AURIX™ TC23x errata sheet

Marking/Step: ES-AB, AB

About this document

Figure 3 Message RAM configurations

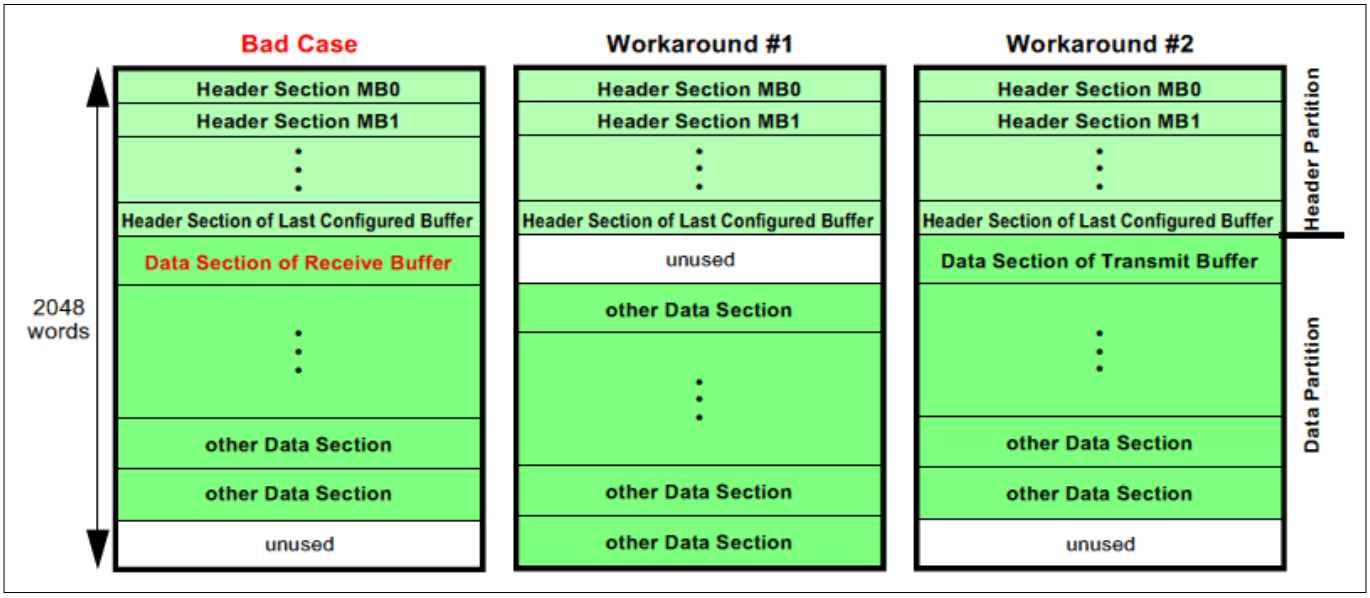
The erratum is limited to the case when (see Figure 3 “Bad Case”):

a) When a message is transferred from the Last Configured Buffer in the Message RAM to the OBF and PLC = 127 it may happen, that at the end of the transfer the OBF word on address 00h (payload data bytes 0 to 3) is overwritten with unexpected data (see Figure 1)
b) When a message is transferred from IBF to the Last Configured Buffer in the Message RAM, it may happen, that at the end of the transfer of the Data Section one additional write access overwrites the following word, which may be the first word of another message's Data Section in the Message RAM (see Figure 2)

Ensure that the Data Section directly following the Header Partition is assigned to a transmit buffer.

Figure 4 Example sequence showing how registers ETRRx may be filled with "Error Free" addresses

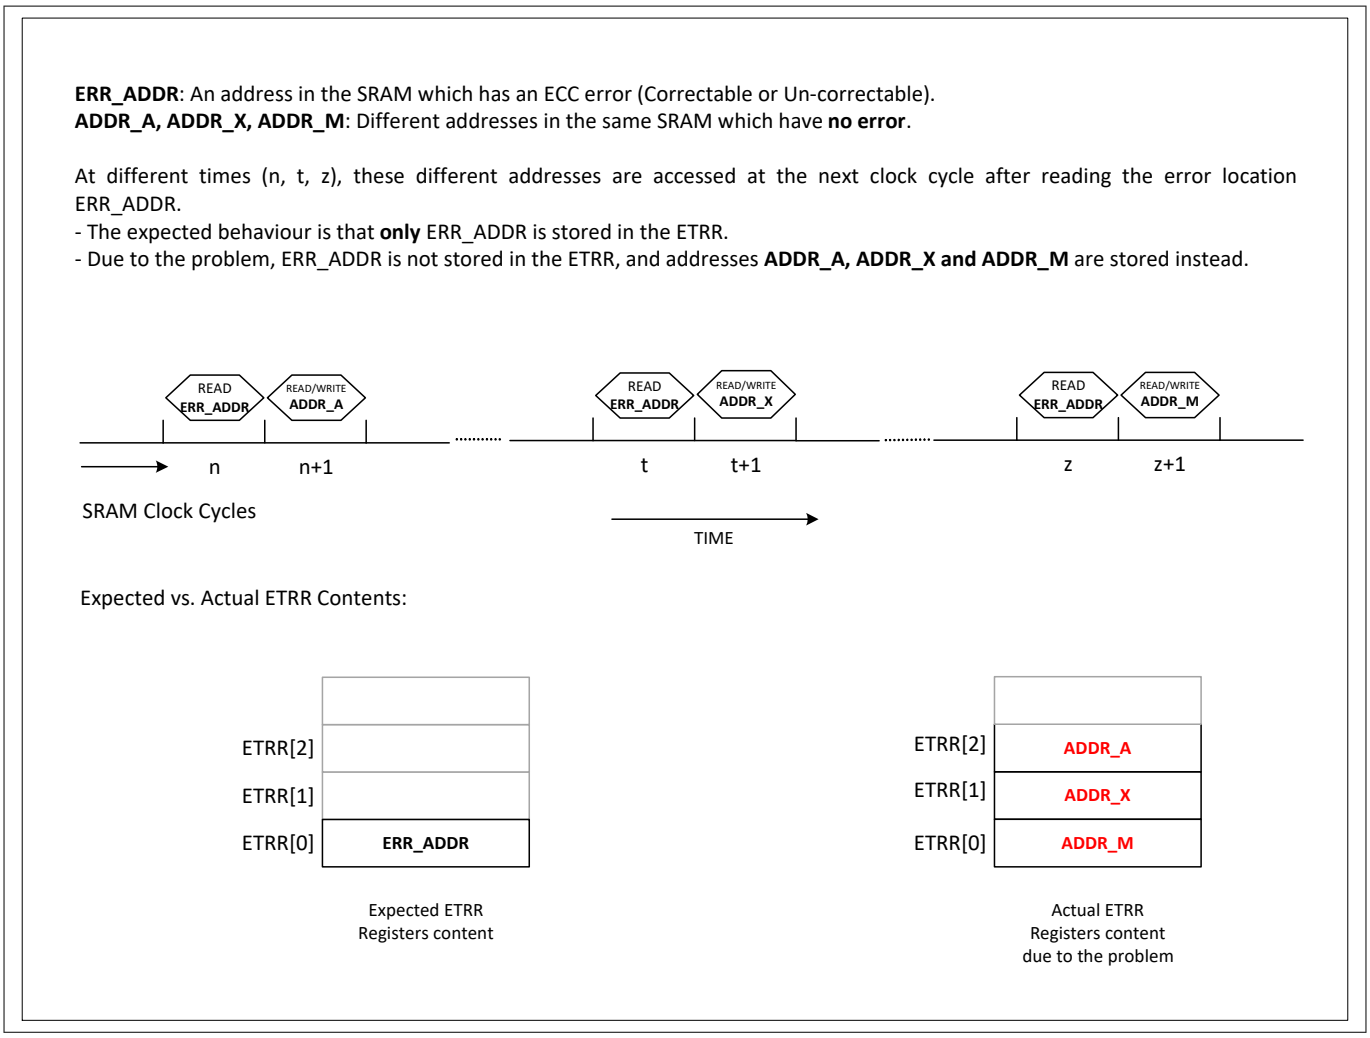
When such a consecutive access sequence (read from ERR_ADDR followed by read/write of different address(es)) happens multiple times, registers ETRRx are filled with addresses that have actually no error – and the SRAM address which actually has an error is not stored indeed. Figure 4 shows such an example scenario.

The consequence of the scenario explained in Figure 4 is that a single error in the SRAM – example just one correctable error at a location ERR_ADDR – can result in registers ETRRx getting filled with fault-free address, and thus potentially even triggering an ETRR overflow.

Figure 5 Recommended Software Handling - Flowchart

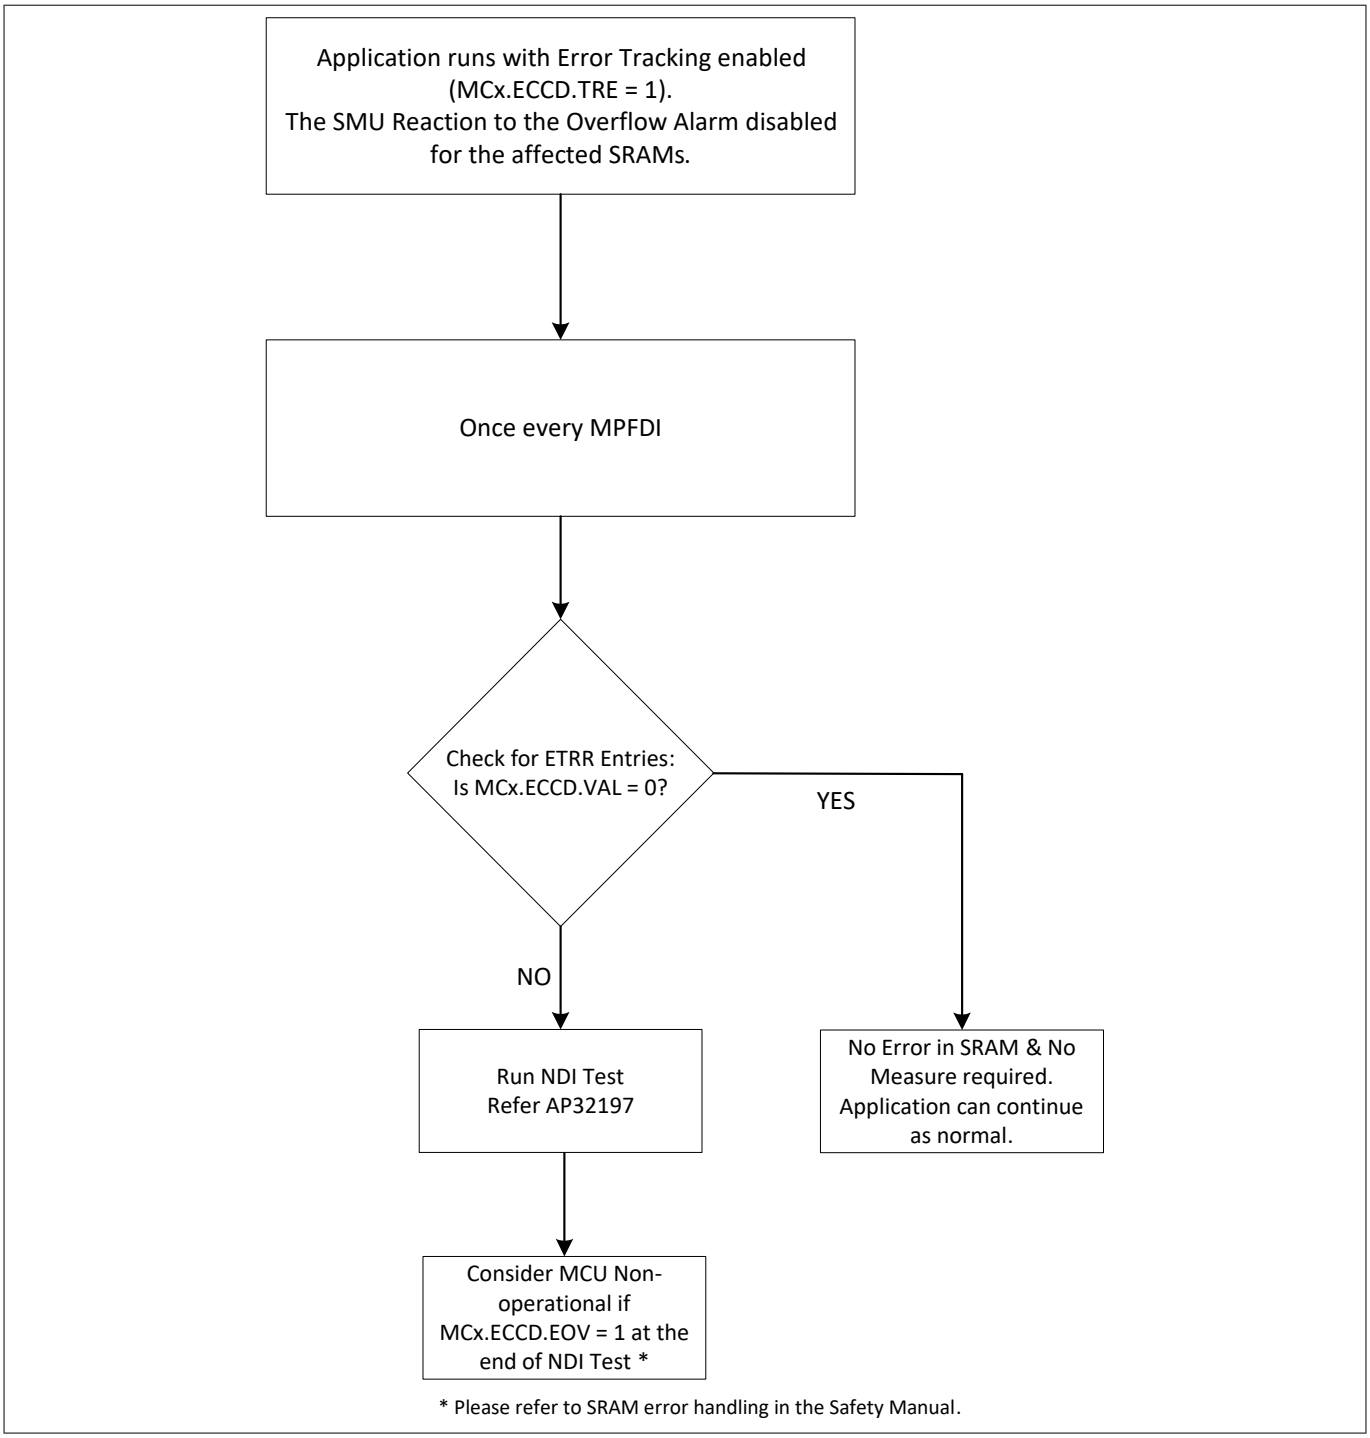
A flowchart of the recommended software handling is shown in Figure 5.

If there is at least one valid ETRR entry (i.e. MCx.ECCD.VAL ≠ 0) then the software shall run a Non-Destructive-Inversion (NDI) Test on the affected SRAM. Please refer to application note AP32197 (AURIX™ Memory tests using the MTU) for an example regarding running this test.

At the end of this test, if an ETRR overflow is detected (MCx.ECCD.EOV = 1_B) then the MCU shall be considered non-operational. Refer to section on Correctable SRAM Error handling in the Safety Manual.

Figure 12 Package Outlines TQFP-144 for TC23x

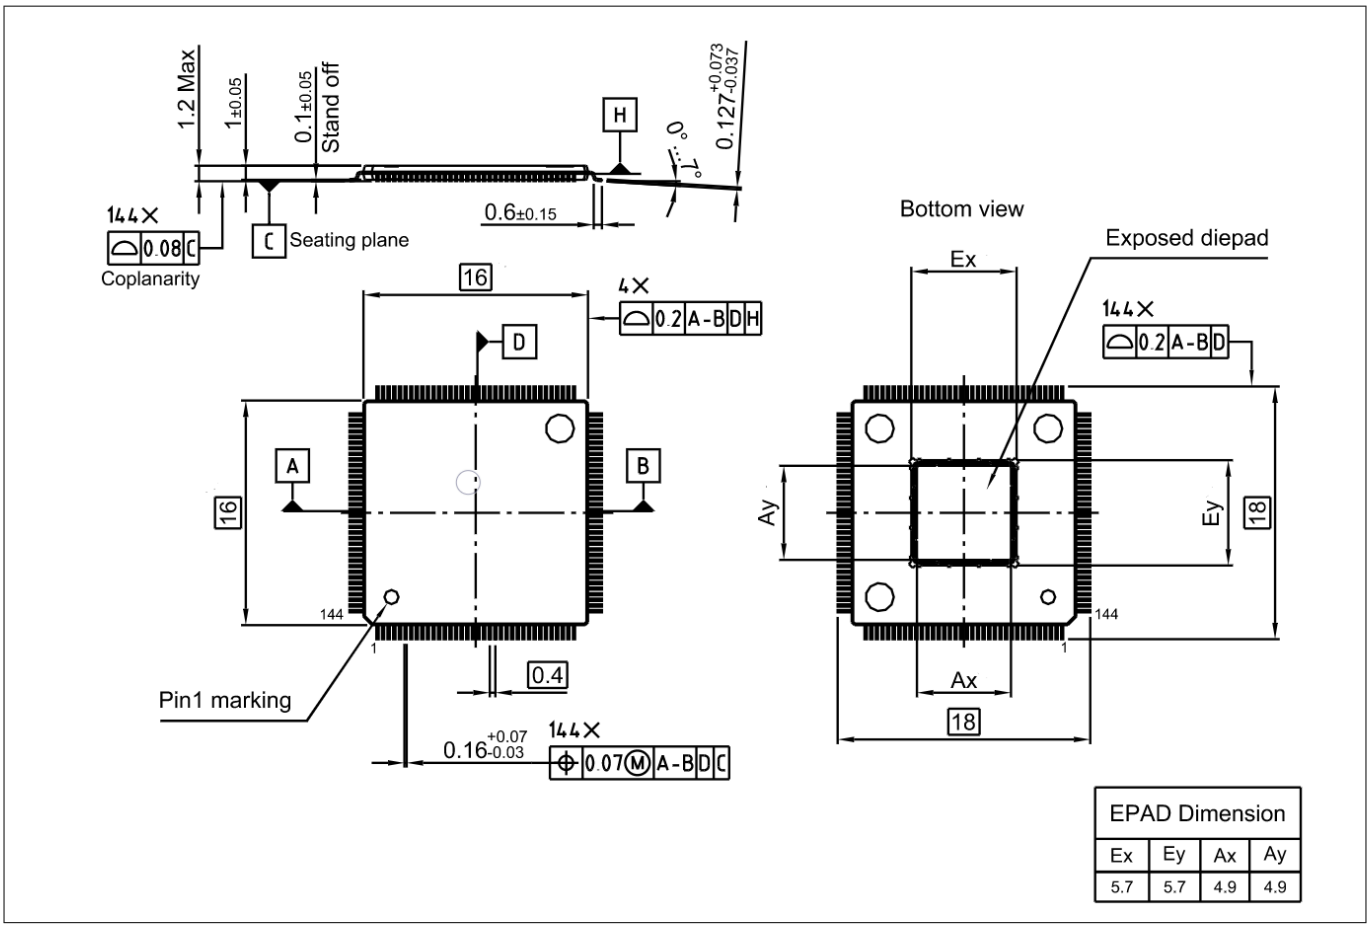
This information shall substitute the corresponding information in the TC23x AC-step Data Sheet V1.0 and in the TC23x A-step Data Sheet V1.1.

***Note**: For the exposed pad of the TQFP-144 package of the TC23x, structural corner protrusions have to be considered for purposes of system design and integration with a maximum boundary of 6.2 mm.*

Figure 13 Package Outlines TQFP-100 for TC23x

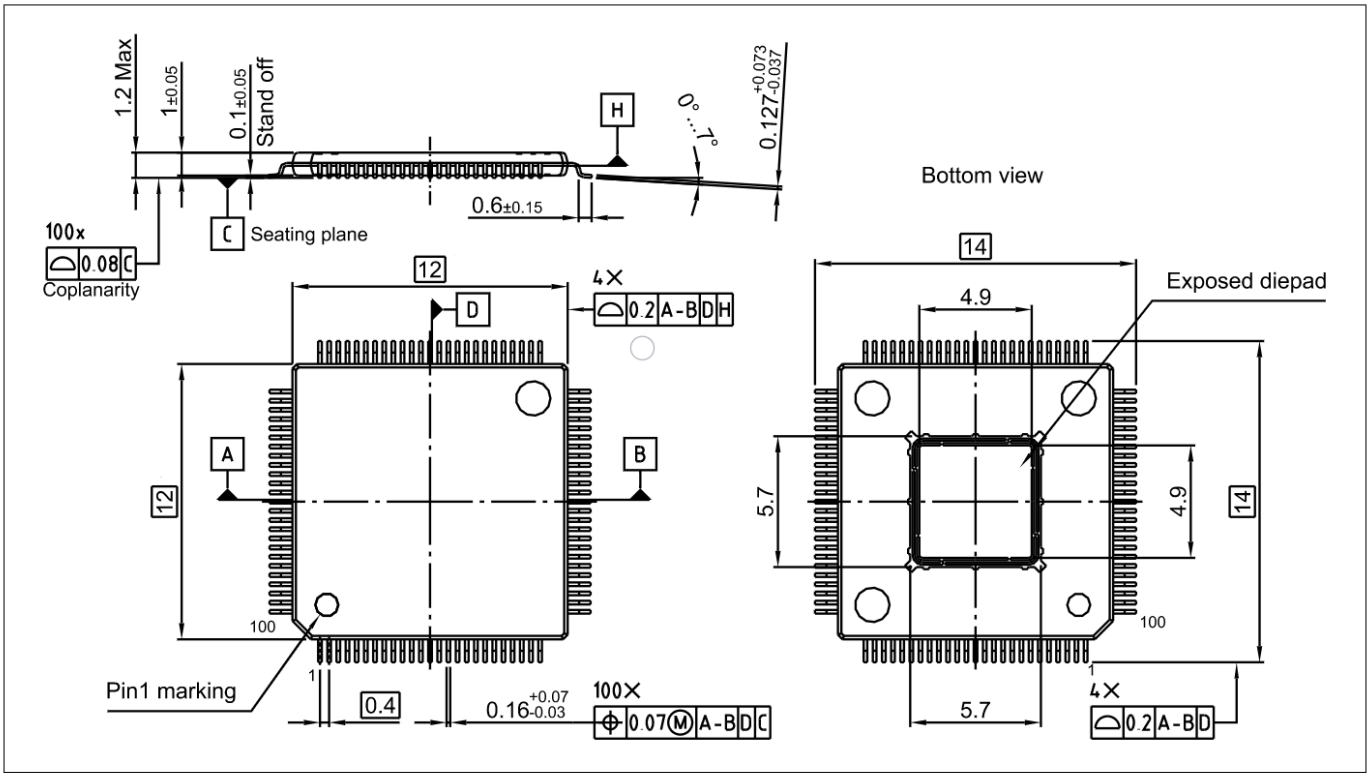
***Note**: For the exposed pad of the TQFP-100 package of the TC23x, structural corner protrusions have to be considered for purposes of system design and integration with a maximum boundary of 6.3 mm.*

Figure 15 Short Serial Message, Serial Data Encoding over 16 messages

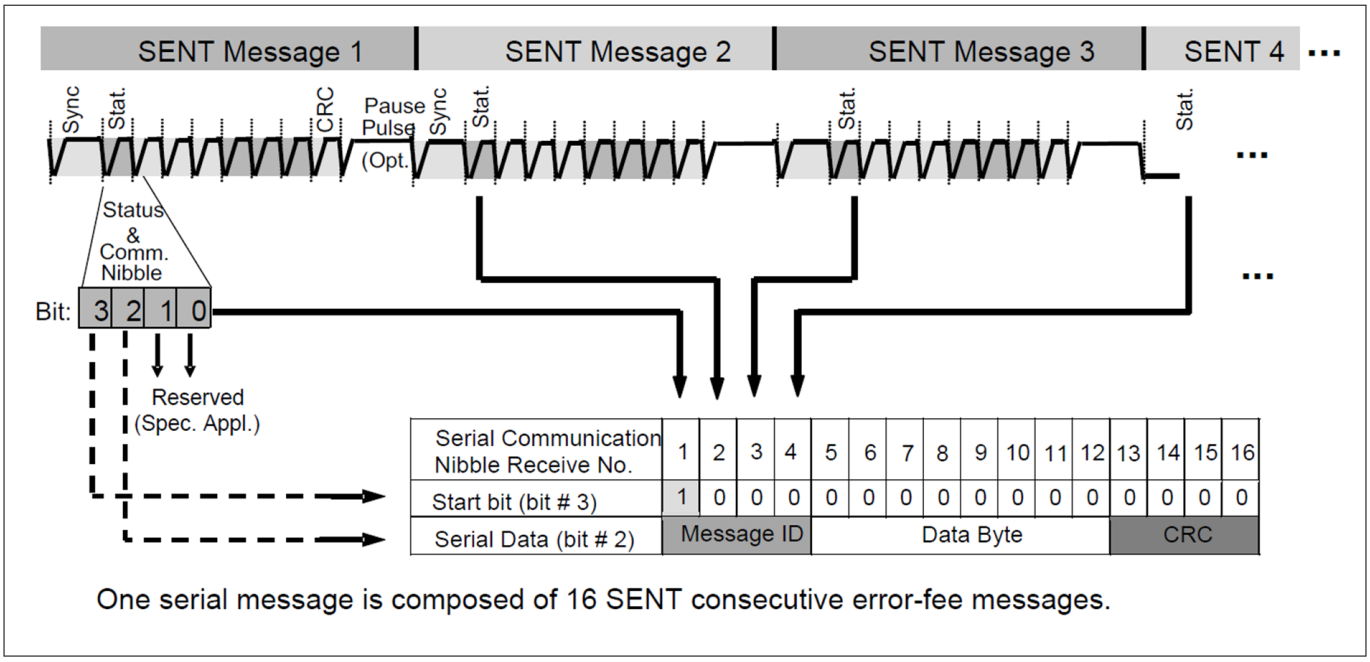
Figure 15 shows a corrected version of this figure.
